## Product Change Notification / RMES-07BGQT464

CCB 5257 Final Notice: Qualification of MMT as an additional assembly site for selected DSPIC33CK32Mx102 and DSPIC33CK64Mx102 device families available in 28L UQFN (4x4x0.6mm) package.

**Pre and Post change comparison  
PCN #: RMES-07BGQT464**

# Pre and Post Change Summary – Lead frame comparison

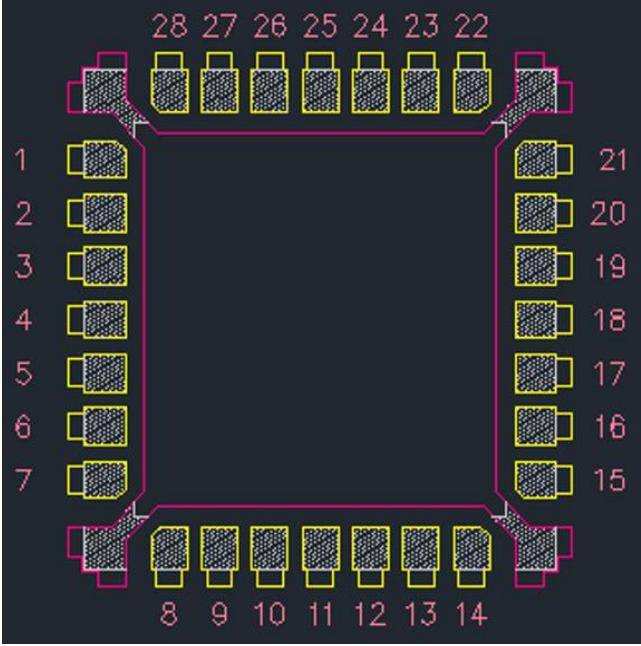
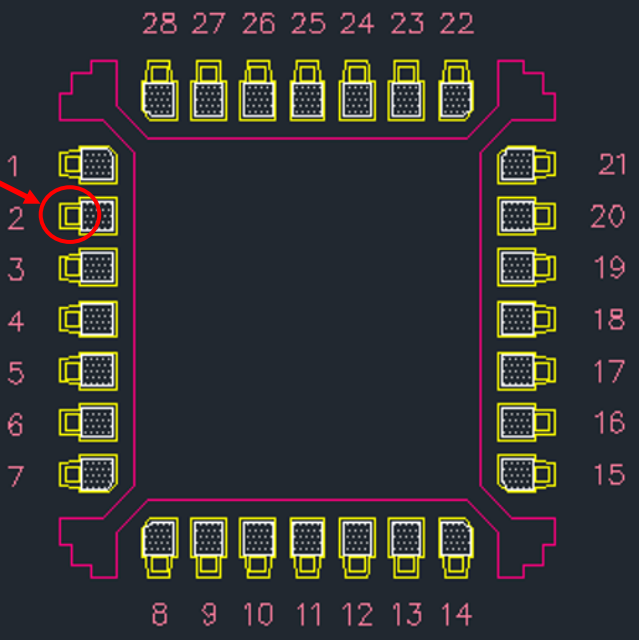
ASE	MMT								
	<p style="margin-bottom: 10px;"><b>Lead-Lock (Locking Holes)</b></p> 								
<table border="1" style="margin: auto; border-collapse: collapse;"> <tr> <td style="padding: 2px 5px;">Lead-Frame Material</td> <td style="padding: 2px 5px;">C7025</td> </tr> <tr> <td style="padding: 2px 5px;">Lead-lock (Locking Holes)</td> <td style="padding: 2px 5px;">No</td> </tr> </table>	Lead-Frame Material	C7025	Lead-lock (Locking Holes)	No	<table border="1" style="margin: auto; border-collapse: collapse;"> <tr> <td style="padding: 2px 5px;">Lead-Frame Material</td> <td style="padding: 2px 5px;">EFTEC64T</td> </tr> <tr> <td style="padding: 2px 5px;">Lead-lock (Locking Holes)</td> <td style="padding: 2px 5px;">Yes</td> </tr> </table>	Lead-Frame Material	EFTEC64T	Lead-lock (Locking Holes)	Yes
Lead-Frame Material	C7025								
Lead-lock (Locking Holes)	No								
Lead-Frame Material	EFTEC64T

Lead-lock (Locking Holes)	Yes

**Note:** Mold compound materials fills the lead lock holes, which provides improved protection against moisture penetration along the edge of the leads (pins) of the package.
